Proposed
71st Street
added Elevation

Close Up
71st Street
Elevation

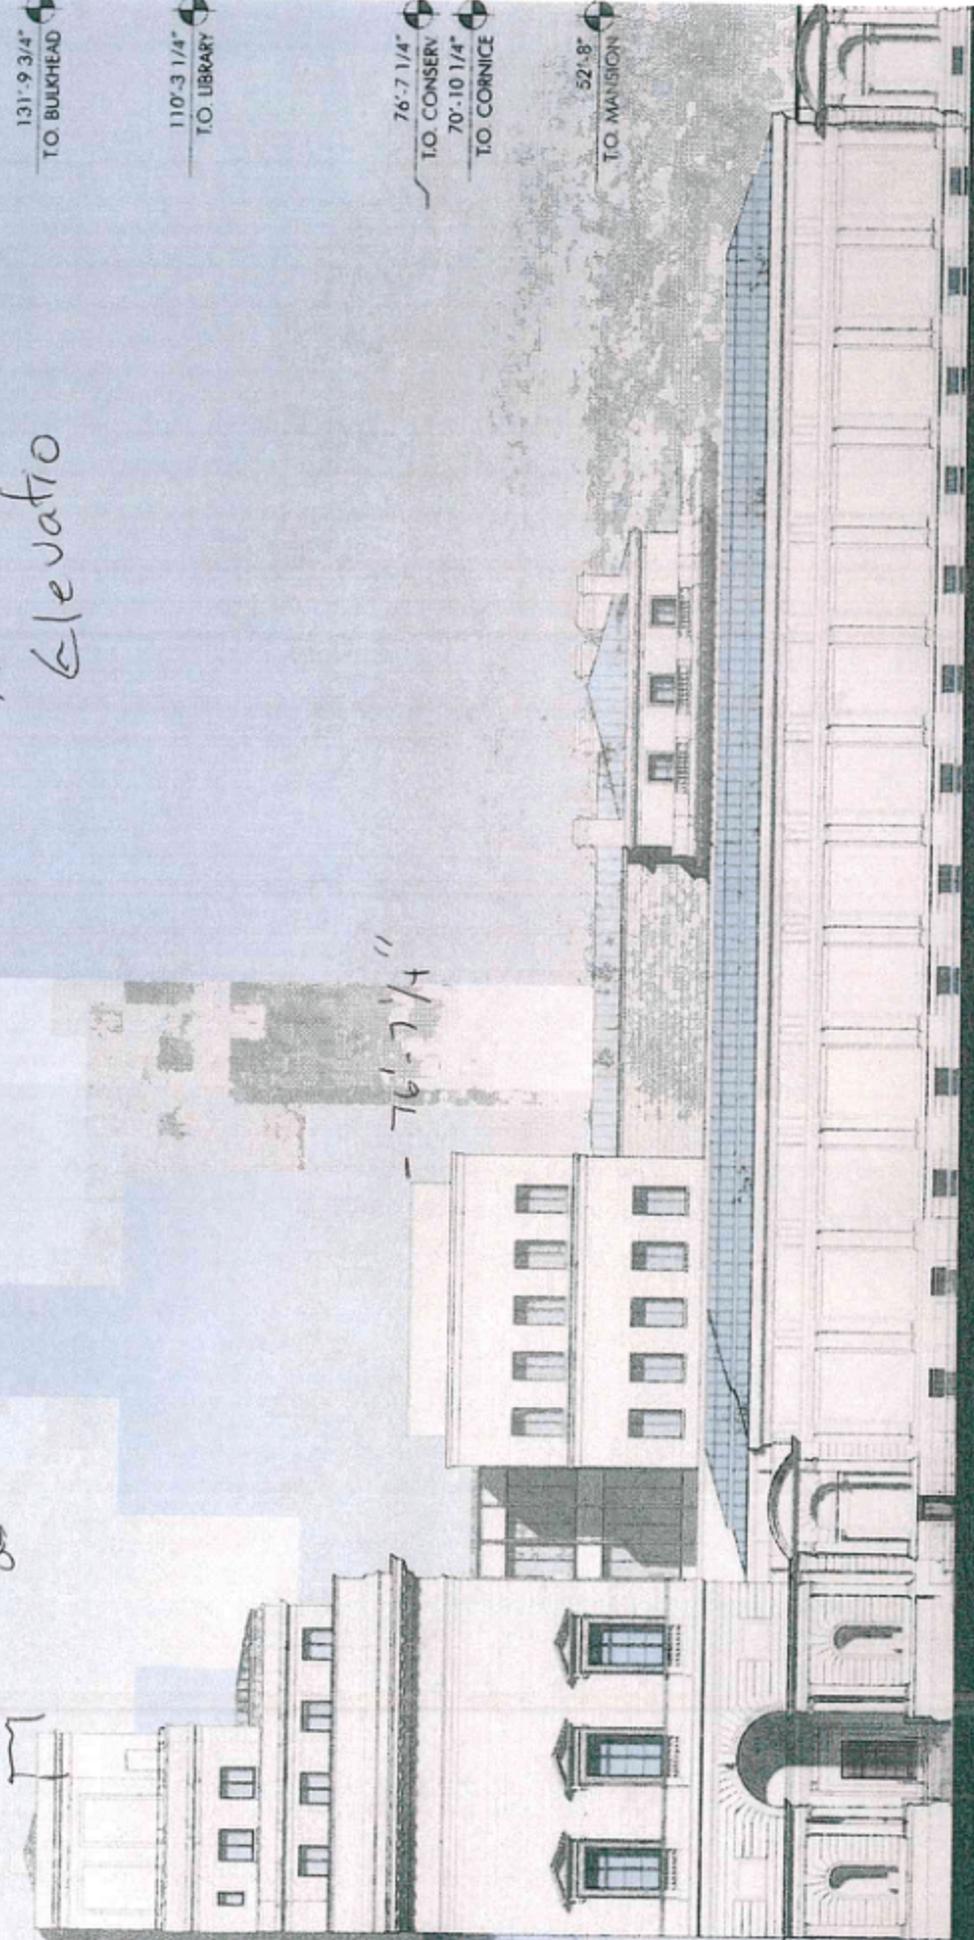
added

changed

handicap
access

new section
same as existing section

PROPOSED 71ST STREET ENTRY

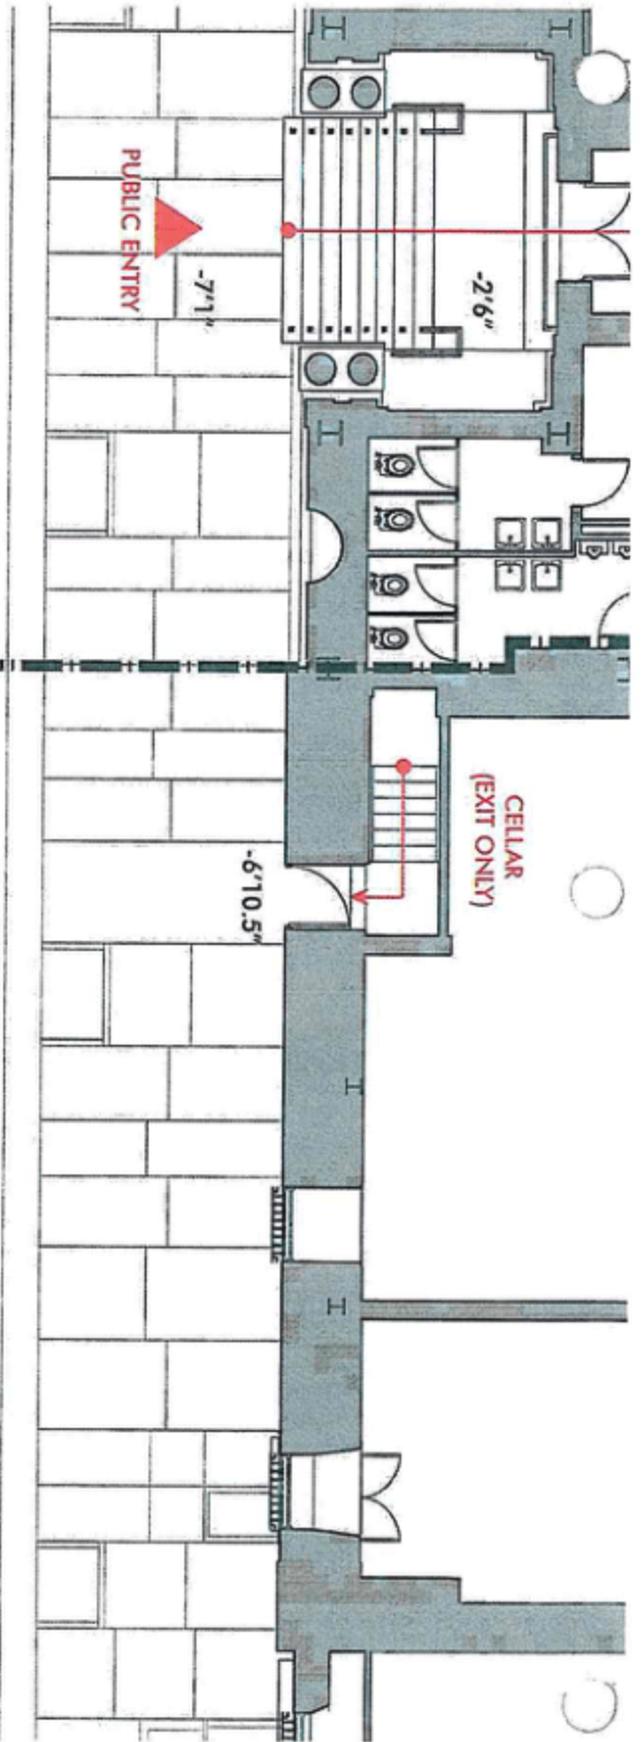
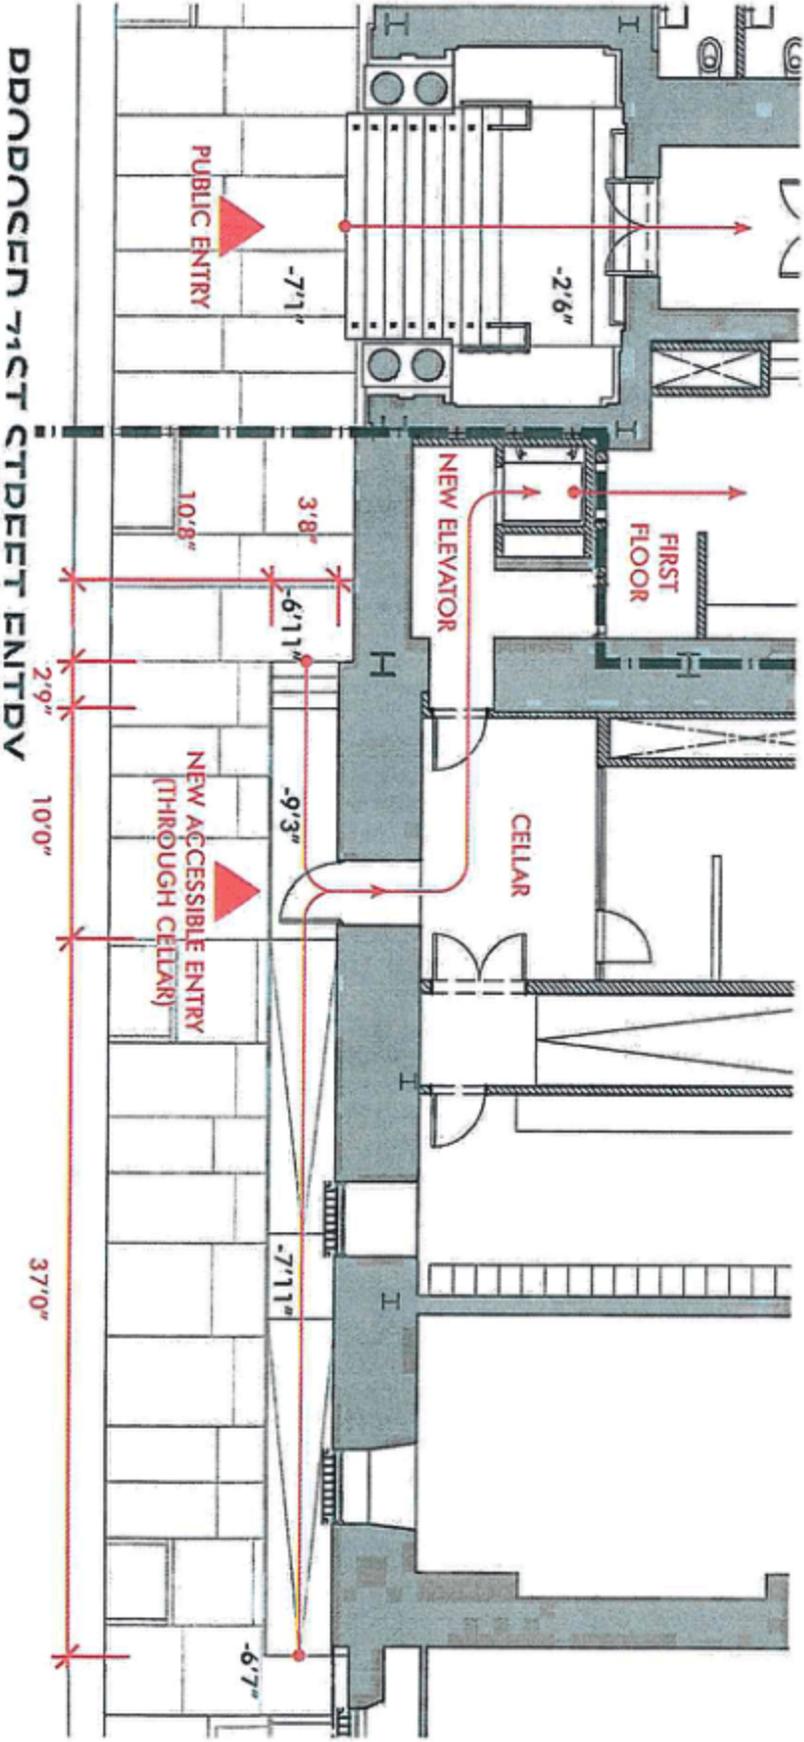
Not clear what this means
